Description: Grove - Oxygen Sensor (MIX8410)

Part Number: 101990680

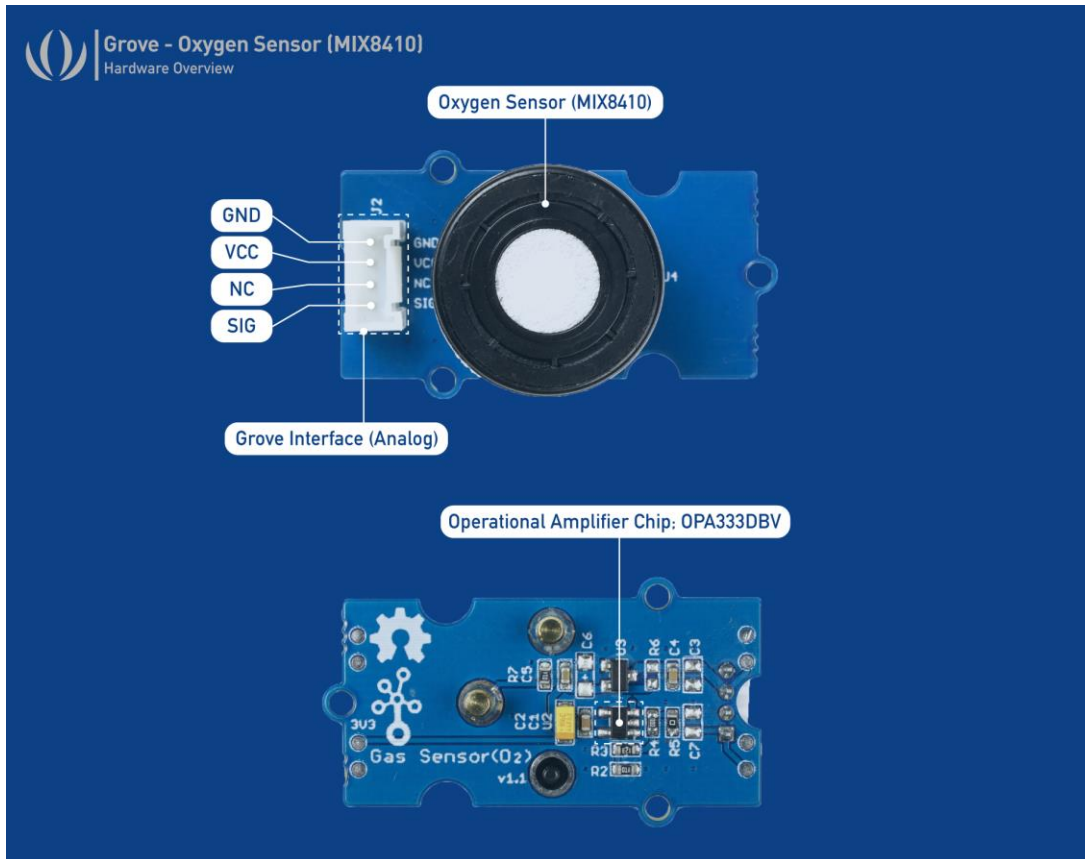
In order to enhance the user experience and improve the quality of the Grove - Oxygen Sensor, we have adopted this new version of the oxygen sensor. The old version was based on the ME2-O2-Φ20 sensor and we now bring you this new version which is based on the MIX8410-O2 sensor.

The following is a comparison of the old and new versions.

Similarities	Differences
Same Bottom pin positions	The new version adopts an advanced anti-leakage technology, which greatly reduces the probability of leakage and solves the leakage problem of the old version.
Same physical dimensions	The output current of the new version is lower, so the electrolyte consumption is slower and the sensor life is longer.
Same driver board	
Same method of use
